**Environmental
Protection Agency**

RE: Medina County
D & R Industries Inc.
NPDES Permit No. OHR000004
Ohio EPA Permit Nos. 3GR00830*DG
and 3GR00120*DG
Industrial Storm Water Inspection

Figure 3 - BMPs must be implemented to address spilled waste materials to minimize or eliminate the potential discharge of pollutants.

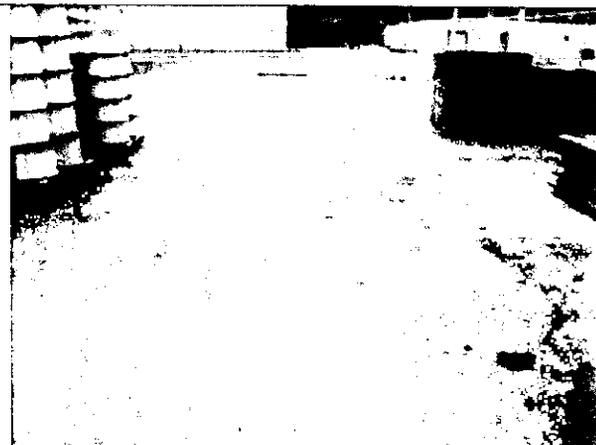
- The roll-off container has been lined to prevent the discharge of potential pollutants. Ohio EPA recommends that the roll-off container be covered due to the current condition and potential for pollutants to leak out of the roll-off container. In addition, spilled waste materials were documented around the roll-off container. BMPs must be implemented to address spilled waste materials to minimize or eliminate the potential discharge of pollutants (Figure 3);
